Access Compliance Report

Public Rights-of-Way

Intersection ID: 23717	Main Street: E WESTINGHOUSE BV	Cross Street: CHINA GROVE CHURCH RD	Location: SE
ADA ID: E3867EBB1AC4	Ramp Type: PerpDiag	Initial Pass/Fail: Fail	Overall Compliance: No
		Severity Score: 12.5

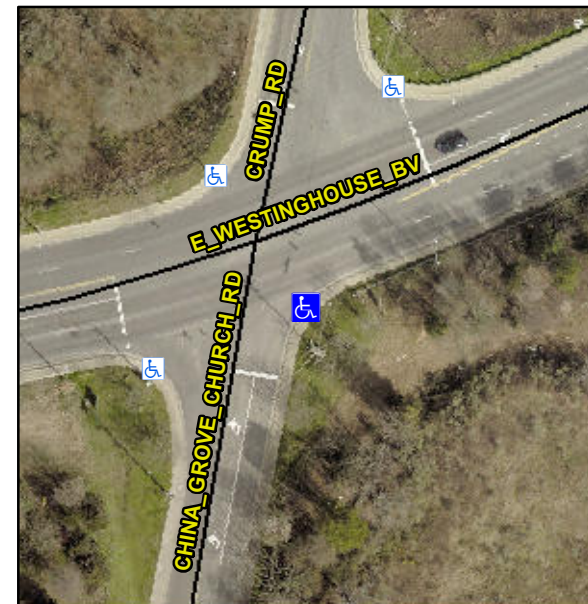
Not Found, R304.2.2

Compliance	Description	Data	Compliance	Description	Data
N/A	Ramp Length (in)	60.0	No	Ramp Slope (%)	11.4
Yes	Ramp Width (in)	48.0	Yes	Ramp XSlope (%)	0.2
N/A	Flare Type LT	N/A	N/A	Flare Type RT	N/A
N/A	Flare Slope LT (%)	N/A	N/A	Flare Slope RT (%)	N/A
N/A	Flare Traversable LT?	N/A	N/A	Flare Traversable RT?	N/A
N/A	Landing Length (in)	N/A	N/A	DWS Provided?	N/A
N/A	Landing Width (in)	N/A	N/A	DWS Contrast?	N/A
N/A	Landing Slope (%)	N/A	N/A	DWS Length (in)	N/A
N/A	Landing X Slope (%)	N/A	N/A	DWS Full Width?	N/A
N/A	Landing Curb? (Y/N)	N/A	N/A	DWS Offset (in)	N/A
N/A	Shared Landing?	N/A			
N/A	Gutter Ponding?	N/A	N/A	Gutter Slope (%)	N/A
N/A	Gutter Lip Ht (in)	N/A	N/A	Gutter X Slope (%)	N/A
N/A	Painted X Walk1?	No	N/A	Painted X Walk2?	No
	X Walk 1 Direction	To NE		X Walk 2 Direction	To SW
N/A	X Walk 1 Width (in)	N/A	N/A	X Walk 2 Width (in)	N/A
	X Walk 1 Slope (%)	2.3		X Walk 2 Slope (%)	2.5
	X Walk 1 X Slope (%)	5.4		X Walk 2 X Slope (%)	2.5

Remove & Replace Curb Ramp With Two New Directional Ramps or Equivalent.
